Permit Type Building/Residential/Addition/SFD Permit Number B26001437 Opened Date 05/04/2026

Description of Work
SFD/ CONSTRUCT 25' X 16' (2)STORY ADDITION WITH BASEMENT TO CREATE GYM, DINING ROOM, MASTER CLOSET, AND LAUNDRY ROOM AND CONSTRUCT 24' X 6' FRONT PORCH, 2 story w/full basement STORY, Full Basement, 3R, 0FB, 0HB, 0FP, OTHER STRUCTURE = None, 0BR, PORCH/DECK = Front Porch, ENERGY METHOD = N/A,

Re: Building Permit Application #B26001437 - For: 14550 MACCLINTOCK DR 4812G6, GLENWOOD, MD 21738

County Comment: "The proposed basement floor plan shows a room that would meet our Howard County bedroom definition".

PROPOSED BASEMENT LEVEL FLOOR PLAN

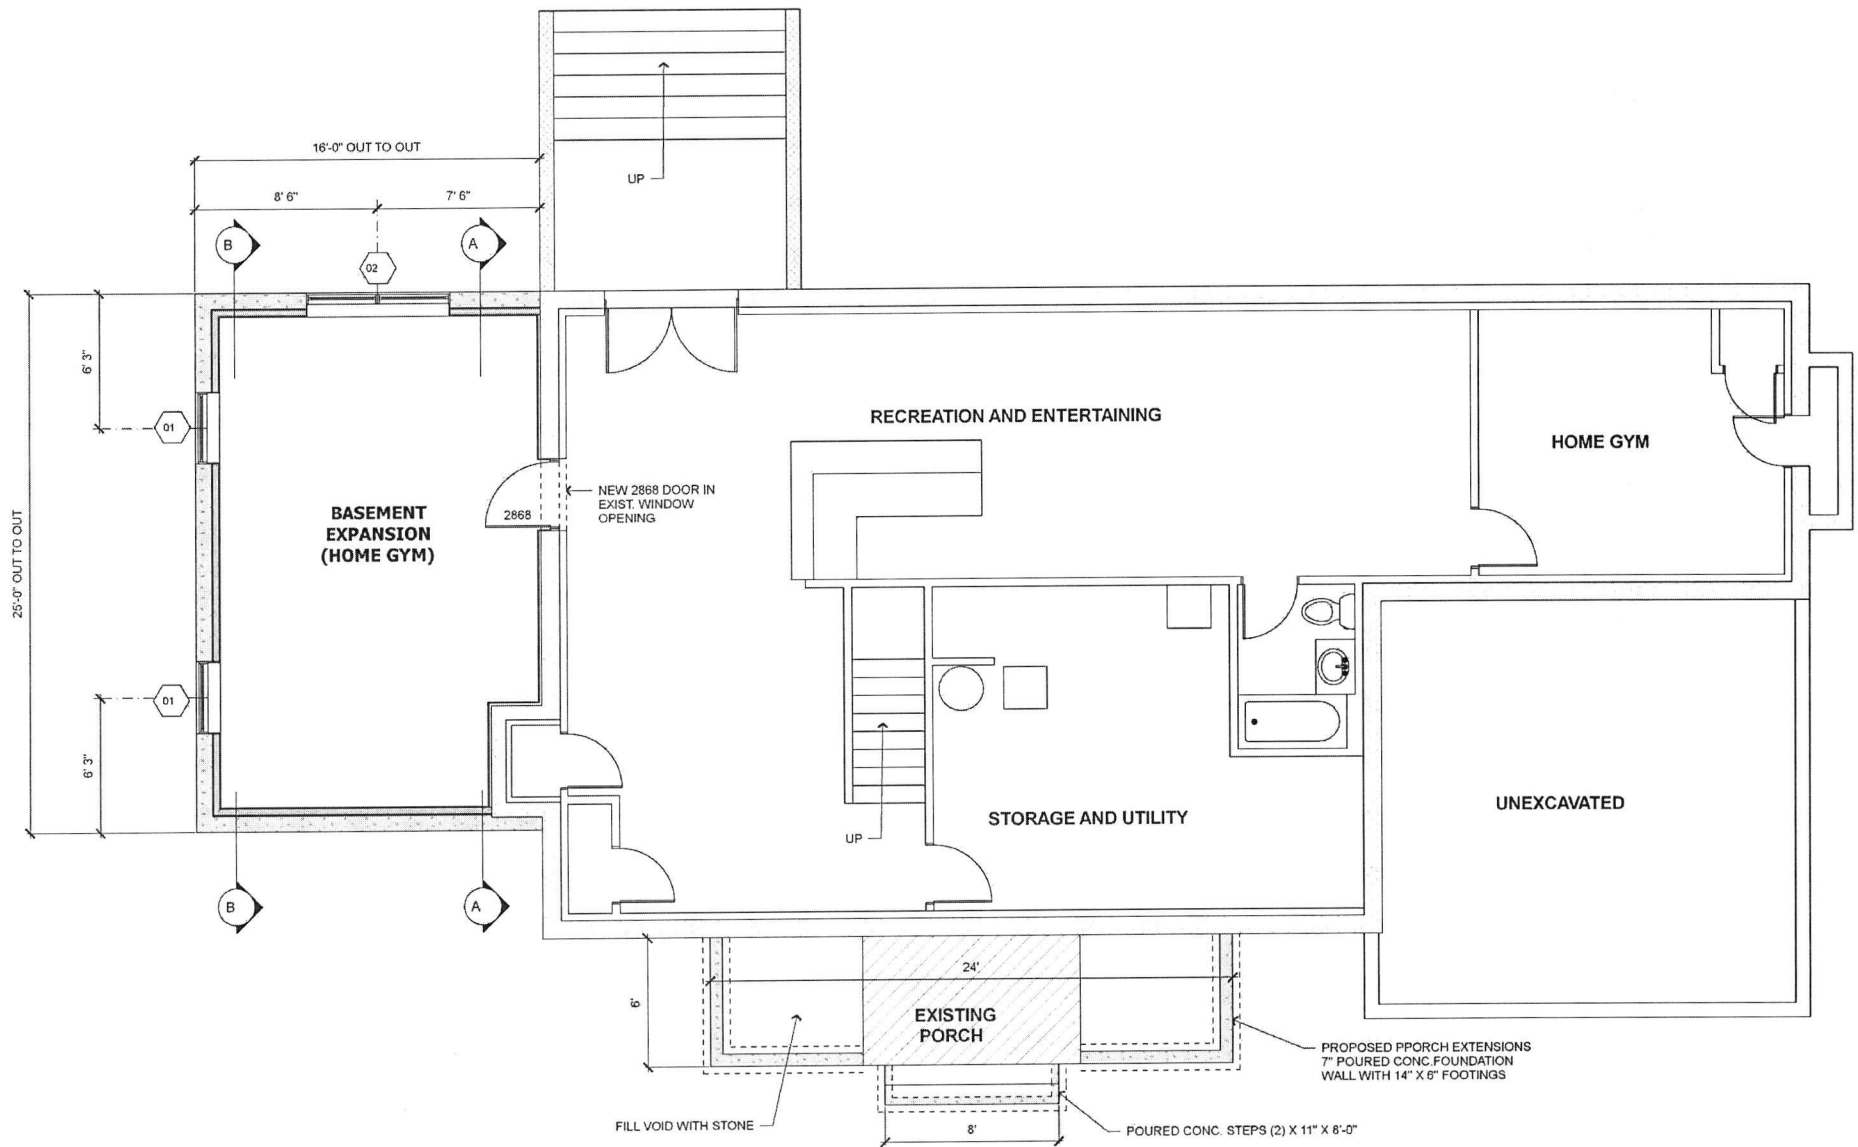
I have reviewed the revised floor plan and would like confirmation that the proposed basement gym will be a 4' cased opening and that no other windows exist in the basement level since the room is not labeled on the revised plan. Once I receive this information I will approve the building permit in the online permit portal. Thank you kindly and have a wonderful day.

After review of the floor plans for B26001437, at 14550 Macclintock Drive, the property currently has a septic system permit & on-site sewage disposal system (OSDS) approved for 4/5 bedrooms. The submitted floor plans reflect 6 bedrooms, and the proposed basement floor plan shows a room that would meet our Howard County bedroom definition (see attached code), therefore increasing one additional bedroom above the permitted septic system design (OSDS plan) under HD review would require upgrades to the existing septic system. To move forward with building permit approval, an OSDS plan submitted by a professional engineer (MDE certified) will need to be reviewed to determine whether upgrading the septic system is feasible. Following the approval of an OSDS plan, then the septic system would need to be upgraded by a licensed septic contractor prior to HD granting permit approval. Otherwise, a revised basement floor plan would be necessary to ensure that the proposed room/s do not meet the criteria of a bedroom as specified in the HC bedroom definition provided. If you should have any questions regarding the bedroom definition or need further clarification please feel free to discuss this proposal with me. Hope you have a wonderful day and thank you kindly.

Response: The proposed basement level room is designed and shall be used by the homeowner as a new Home Gym. The gym, along with a large dining room for family gatherings and an improved / updated primary suite were the three major goals of this expansion.

There are no closets and the room does not have any "rough-ins" or direct access to a bathroom. The proposed doorway is cut through the existing 12" steel reinforced, concrete foundation wall below a current basement window so not to affect the structural concrete lintel above. If necessary, we are willing to expand the width of this opening to meet the intent of the code, up to 4'-0" as requested but any additional "1/2 height walls" will not be an option due to the loads that are imposed currently and proposed on this foundation, bearing wall.

Ms. Eshenbaugh, Yes that is correct , the proposed basement gym will be a 4' cased opening I have labeled the room on the revised plan, which is attached , please confirm that this is acceptable.

Please be advised that the Architect will be revising the plans to show a four (4) foot opening between the proposed Gym and the existing basement. Please proceed with site visit as soon as you are able . Thank you.
